Piper Aircraft, Inc.
2926 Piper Drive
Vero Beach, Florida, U.S.A. 32960

SERVICE BULLETIN

NO. 840A

FUEL SELECTOR VALVE COVER REPLACEMENT

Figure 1

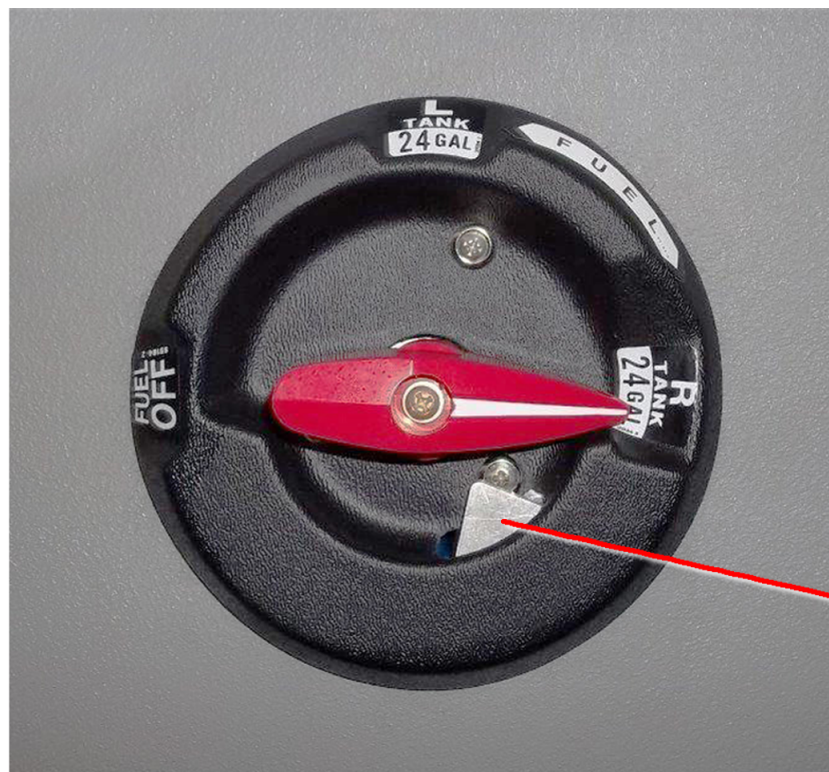
To announce the availability of a new fuel selector valve cover assembly and mating handle, which reduces the possibility of pilot mismanagement of the fuel system through inadvertent selection to the "OFF" position, resulting in power interruption or stoppage.

NOTE: Figure 1 shows the replacement fuel valve cover properly installed.

NOTE: Figure 1 shows proper installation of Piper Part Numbers 760-545 and 760-546. P/N 760-545 is similar to 760-546, except 760-545 includes additional parts and instructions to accommodate an adjacent cabin air vent (cabin air vent not shown in Figure 1).

All instructions necessary to accomplish this modification are contained in Piper Kit No. 760-545, Fuel Selector Valve Cover Replacement.

All instructions necessary to accomplish this modification are contained in Piper Kit No. 760-546, Fuel Selector Valve Cover Replacement.
